TOWNSHIP 3 NORTH, RANGE 29 EAST, WILLAMETTE MERIDIAN, UMATILLA COUNTY, OREGON.

CORRECTED RECORD OF SURVEY

RECEIVED BY
Umatilla County Surveyor
Date: 12/17/17
Rec'd By: [Signature]
No.: 11-038-C (corrected)

AFFIDAVIT of CORRECTION (Survey Plat)

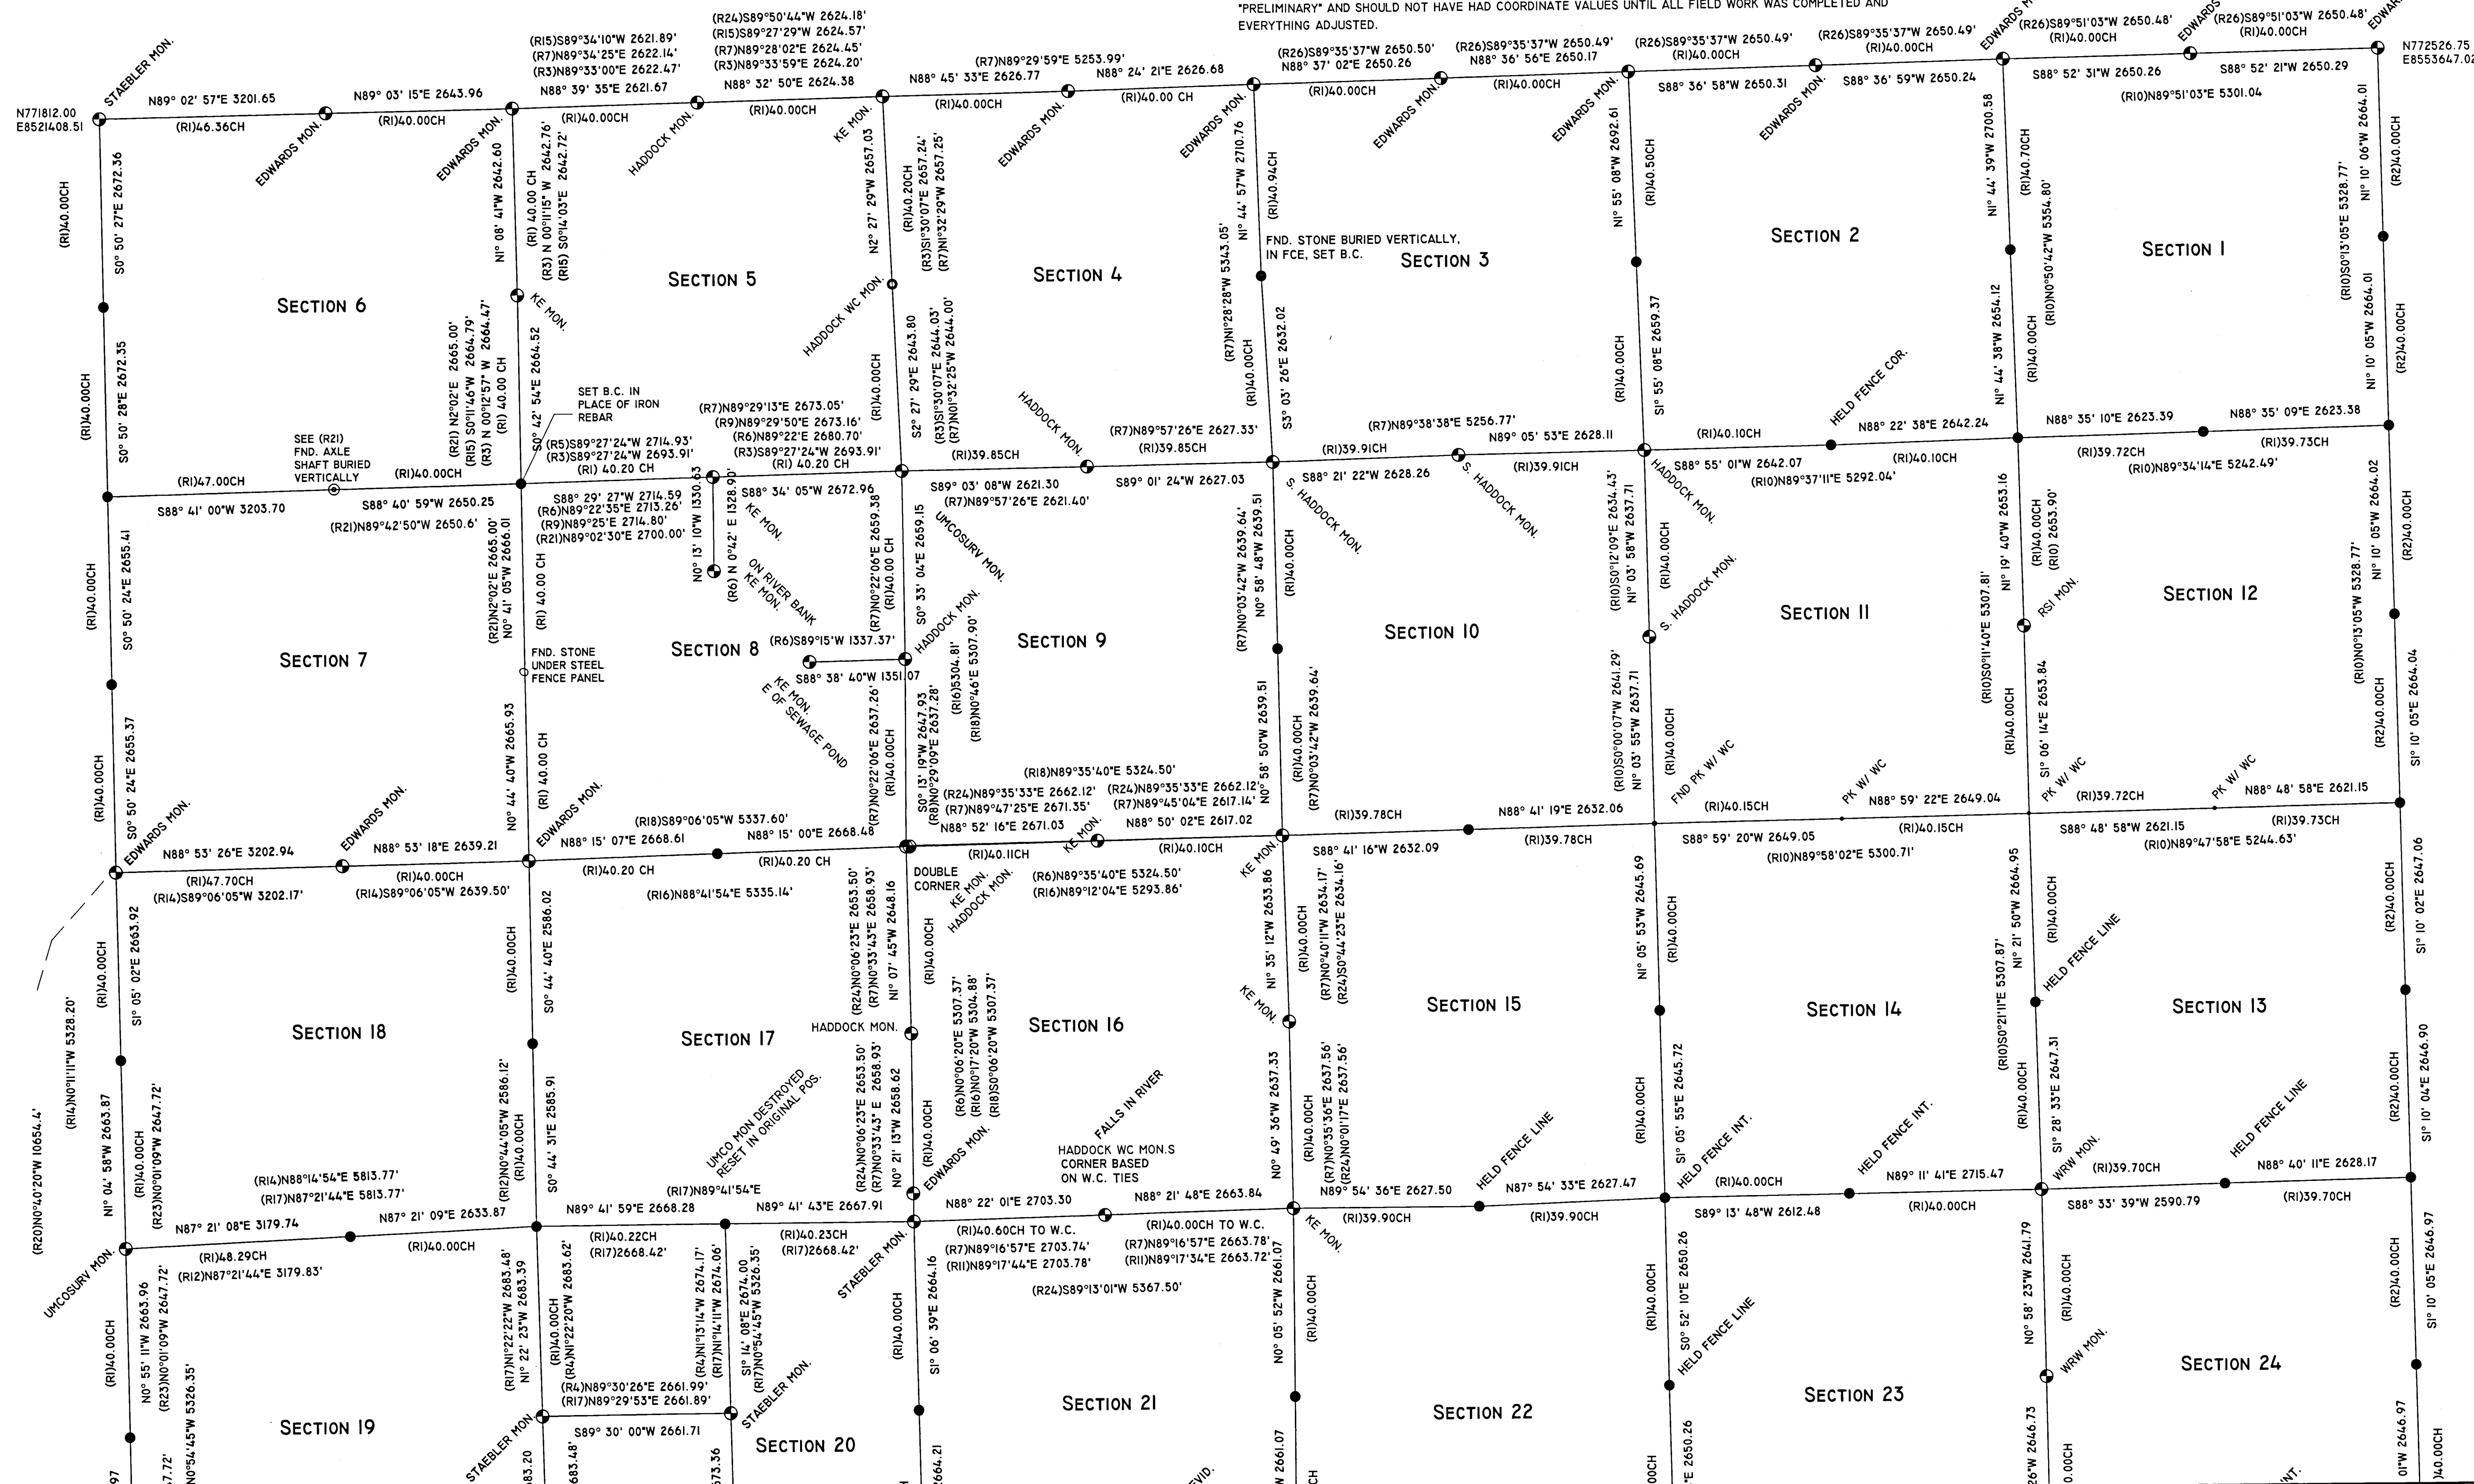
CORRECTIVE NARRATIVE:

IT WAS BROUGHT TO MY ATTENTION THAT I HAD SOME LINE-WORK ISSUES ON COUNTY SURVEY II-38-C. I FOUND THAT MY AUTOCAD SOFTWARE HAD ISSUES CLIPPING TO THE ACTUAL SURVEY NODES ON THE DRAWING IN SEVERAL PLACES. THIS CORRECTIVE PLAT FIXES FOUND ERRORS IN BEARING AND DISTANCE CALLS. THE 1/4 CORNER COMMON TO SECTIONS 18 AND 19 WAS ERRONEOUSLY PROPORTIONED BY 1.0 FOOT, AND THE COORDINATES TO THE 1/4 CORNER COMMON TO SECTIONS 25 AND 36 WAS INCORRECTLY REPORTED. BECAUSE OF SAID ERRORS I COMPLETELY REVIEW ALL LINE-WORK AND LAND CORNER RECORDS TO INSURE THAT THERE WAS NOTHING ELSE THAT WAS MISSED. AN AFFIDAVIT OF CORRECTION IS FILED SEPARATELY ADDRESSING EACH INDIVIDUAL ISSUE. AFTER MEETING WITH DAVID H. KRUMBEIN, UMATILLA COUNTY SURVEYOR, ON SEPTEMBER 27, 2017, HE SUGGESTED I FILE THIS CORRECTIVE PLAT TO ADDRESS SAID ERRORS, AND FILE AFFIDAVITS CALLING OUT THE CORRECT FILED LAND CORNER RECORDS AND LIST ANY CORRECTIONS MADE. FOR THE RECORD, ONLY LAND CORNER RECORDS THAT ARE REFERENCED TO I2-094-C OR ARE LISTED WITH XXX-II-XXX HAVE THE CORRECT NAD83 ORNSPC COORDINATES. DUE TO THE LENGTH OF TIME NEEDED TO COMPLETE THIS CONTRACT, IN ACTIVE FARM GROUND, I FELT COMPELLED TO FILE WHAT SHOULD HAVE BEEN LABELED 'PRELIMINARY' AND SHOULD NOT HAVE HAD COORDINATE VALUES UNTIL ALL FIELD WORK WAS COMPLETED AND EVERYTHING ADJUSTED.

It has come to my attention that I had a CAD issue, and some of the line work on this map of survey
exhibits the wrong bearing and distances due to lines not snapping correctly to the data nodes.
Corrections, as noted and read from left to right on the map of survey, to wit:

- 1) The West line of Section 6 should be: [S0°50'28"E 2672.35' and S0°50'27"E 2672.36'] respectively.
- 2) The line common to Sections 9 and 16 should be: [N88°52'16"E 2671.03' and N88°50'02"E 2617.02'] respectively.

- 3) The line common to Sections 18 and 17 should be: [S0°44'31"E 2585.91' and S0°44'40"E 2586.02'] respectively. I held an old fence corner, buried in the edge of an irrigation canal, with a monument of record lying on the ground at this location.

- 4) The 1/4 corner common to Sections 18 and 19, was erroneously proportioned and should be: [N87°21'08"E 3179.74' and N87°21'09"E 2633.87'] respectively. The monument was repositioned to this correct location. See Item n) below for the corrected N3 NAD83 ORNSPC coordinates and accessories.

- 5) The West line of Section 19 should be: [N0°55'10"W 2663.97' and N0°55'11"W 2663.96'] respectively.
- 6) The line common to Sections 20 and 21 should be: [S1°06'45"E 2664.21' and S1°06'39"E 2664.16'] respectively.

- 7) The line common to Sections 21 and 28 should be: [N86°40'37"E 2637.71' and N89°52'53"E 2637.41'] respectively.
- 8) The line common to Sections 21 and 22 should be: [N0°05'52"W 2661.07' and N0°05'52"W 2661.07'] respectively.

- 9) The line common to Sections 22 and 27 should be: [N88°41'10"E 2669.57' and N88°41'09"E 2669.59'] respectively.
- 10) The line common to Sections 23 and 24 should be: [N0°49'26"W 2646.73' and N0°58'23"W 2641.79'] respectively.

- 11) The line common to Sections 24 and 25 should be: [S88°40'35"W 2621.92' and N88°40'37"E 2621.87'] respectively.
- 12) The line common to Sections 30 and 29 should be: [N1°09'05"W 2685.19' and N1°09'05"W 2685.19'] respectively.

- 13) The line common to Sections 29 and 28 should be: [N1°10'52"W 2631.45' and N1°10'52"W 2631.46'] respectively.

14) The line common to Sections 28 and 27 should be: $N1^{\circ}24'41''W$ 2661.86' and $N1^{\circ}24'41''W$ 2661.89' respectively.

15) The line common to Sections 25 and 36 should be: $S88^{\circ}24'39''W$ 2605.08' and $S88^{\circ}40'56''W$ 2638.18' respectively. See Item v) below for the correct V23 NAD83 ORNSPC coordinates.
